CUP-12-02/DR-12-04 (water treatment plant) and CUP-12-04/DR12-14 (water transmission line)

Lake Oswego WTP application (CUP 12-02) and RWP/FWP application (CUP 12-04)

The purpose of this memorandum is to identify changes to the land use application materials that have evolved since September 2012 as the projects worked towards 60% design. This memorandum includes a matrix identifying the changes made to the application materials and the location of the changes within the application materials. The changes are specific to the WTP.

Land Use Submission: Drawing Update Outline

Figure 14A-1. WTP Construction Schedule

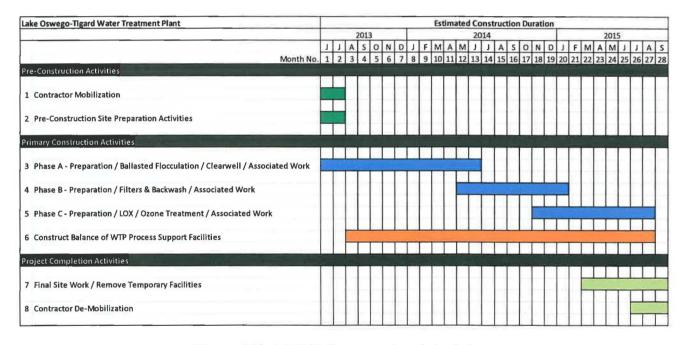
The design team has decreased the overall project construction schedule from 32 months to 28 months. Shortening the duration of the project by four months will result in a slight increase in the volume of daily and hourly construction traffic and related impacts during construction but will significantly decrease the amount of time that residents experience these impacts. Figure 14A-1, WTP Construction Schedule, shown below incorporates the decreased construction duration and replaces the figure by the same name in previous land use application submittals. All project phases remain the same as previous applications submittals, but each project phase duration has been shortened to obtain the cumulative duration decrease of four months.

Stormwater Report, Figure 2.0

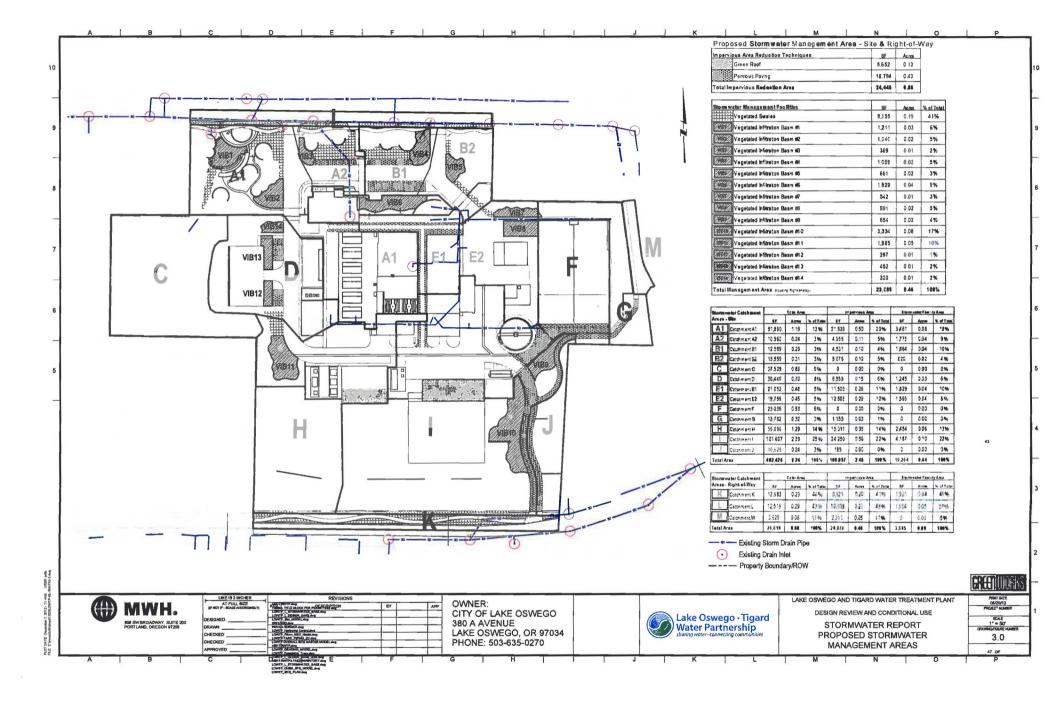
Pervious Surfaces = 7,849 sf (27% of ROW)
 Impervious Surfaces = 20,970 sf (73% of ROW)

See attached Figure 2.0 for more detailed area breakdown

September 27 Update - Figure 1. Combined construction project traffic on Mapleton Drive

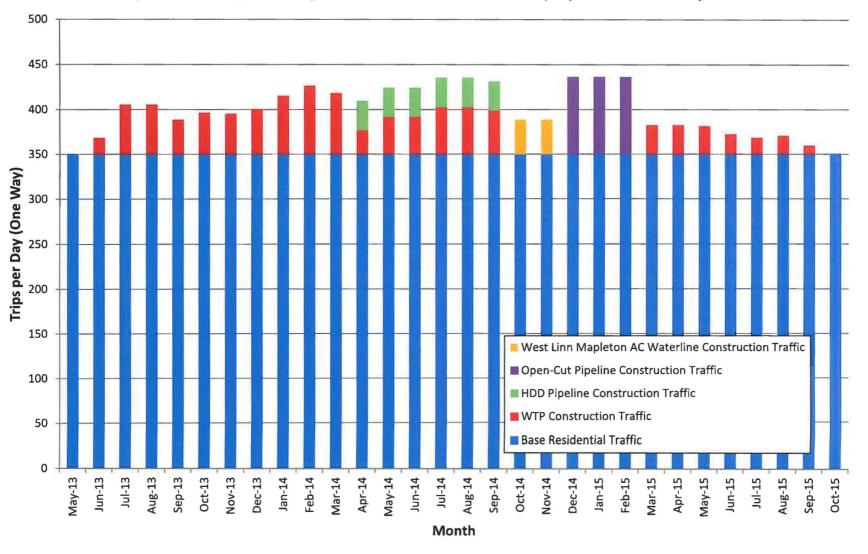
The September 27 land use application memo included combined construction related traffic on Mapleton Drive and Kenthorpe Way resulting from WTP and pipeline construction related activities. Updated Figures 1 and 2 are included in this document and reflect the four month decrease in WTP construction duration. Due to the change in WTP and pipelines construction overlap the maximum one-way construction traffic on Mapleton Drive will remain at 86 trips per day and the maximum one-way construction traffic on Kenthorpe Way will be reduced from 95 trips per day to 91 trips per day.
